TG12.1 – Civil/Sitework at Grade/Ground Level Landscaping

Questions are numbered in the order received. Numbers missing in the sequence either have been answered in a previous response set or will be answered in a future set.

ISSUED FOR CONSTRUCTION

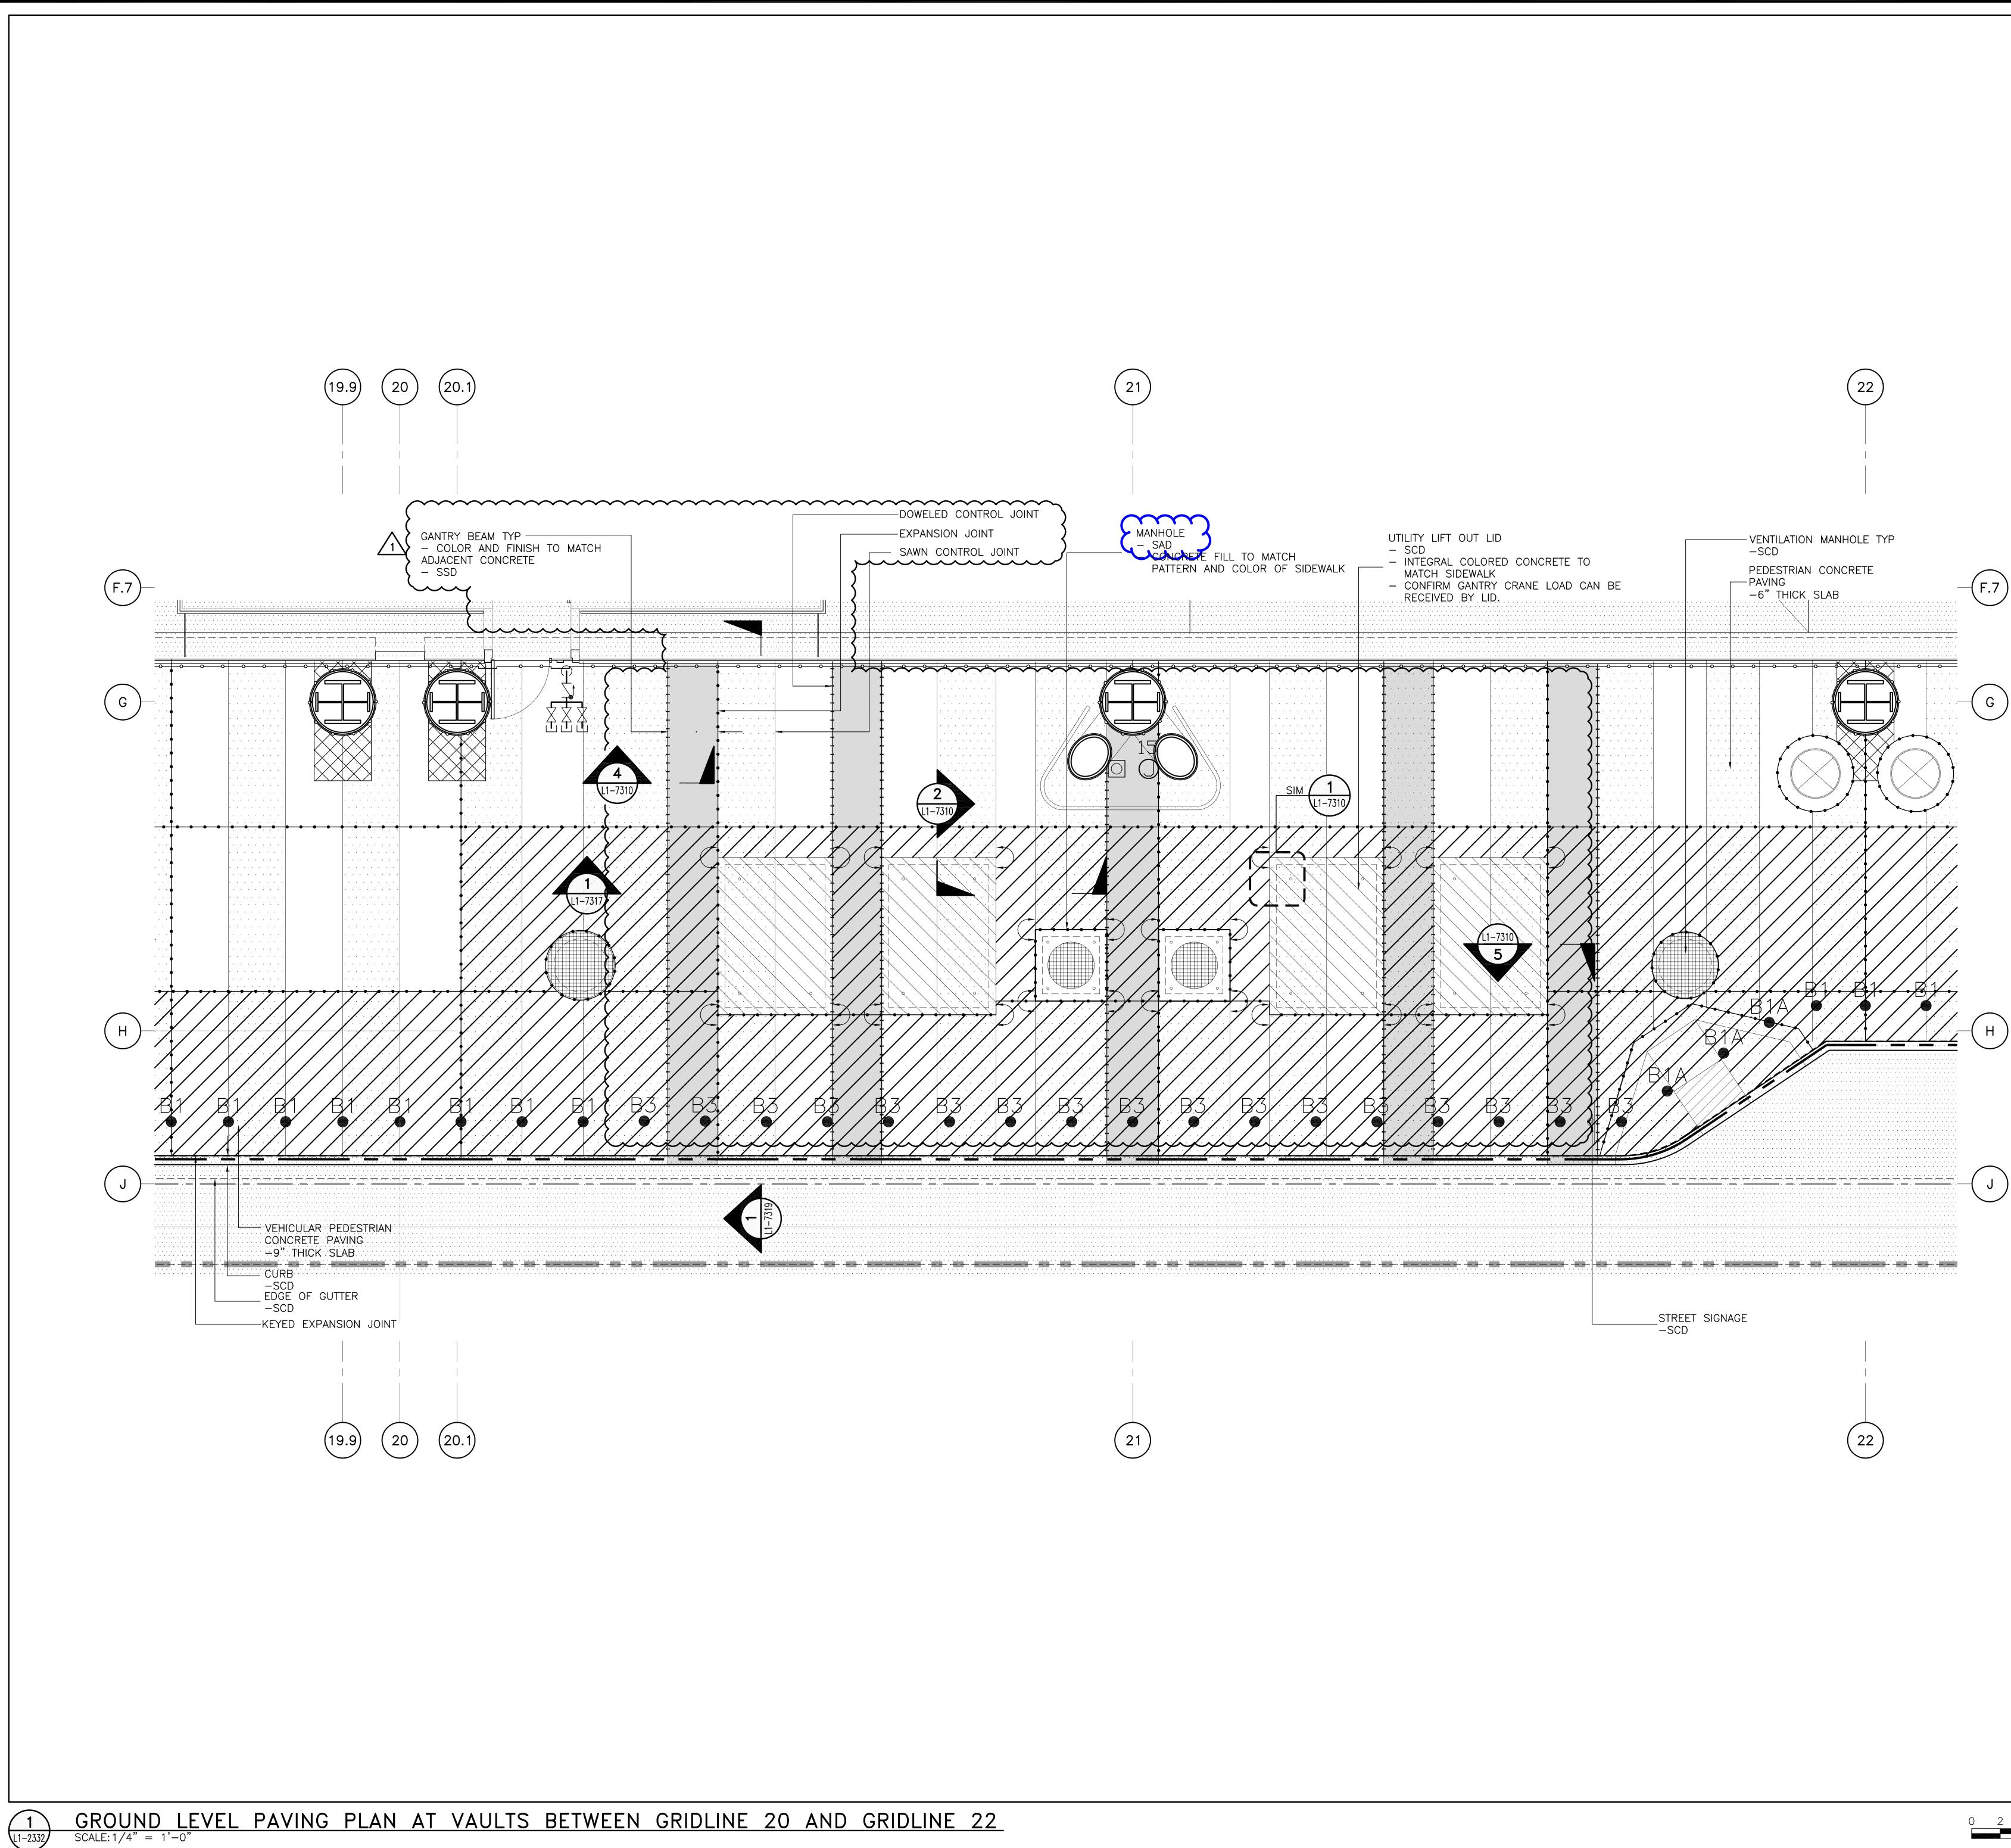
TG12.1- 025	5/18/2015			The columns/shafts for the temporary bridges to be removed are nominally 48" diameter, but due to required construction methods (drilled shaft) they are typically larger. What is the maximum diameter of the columns to be removed? Will the TG12.1 Trade Subcontractor be required to perform any chipping to allow removal of these columns, as detailed in the Temporary Bridges Removal Narrative? If so, how much?	CIDH drilled piers vary in diameter as they were installed without sleeves; chipping will be necessary if the TG12.1 Trade Subcontractor chooses to cut and remove through the blockout. A jobsite visit is strongly recommended to assess the extent of the chipping as each of the CIDH piers vary in size. See attached submittals for reference.
TG12.1- 026	5/18/2015	L1-2330 - L1- 2332, L1-2302 - L1- 2304		Plan Sheets L1-2330 through L1-2332 show ventilation manholes and ventilation grates within lift out lids, with notes to "SCD" (See Civil Drawings). No details are provided in the Civil or Landscape Drawings. Similarly, there are "Fuel Intakes" (per Legend) shown on Plan Sheets L1-2302 & L1-2304 with the note "SED" (see Electrical Drawings). No details were found. Please provide details for all three of these features as they relate to the work of TG12.1.	The reference notes in drawings have been amended to state "SAD." Refer to architectural details 9/A1-8717 and 1 & 4/A1- 9239 for these elements. See attached sketches SKLA-432.1 through SKLA-432.4 for clarification.
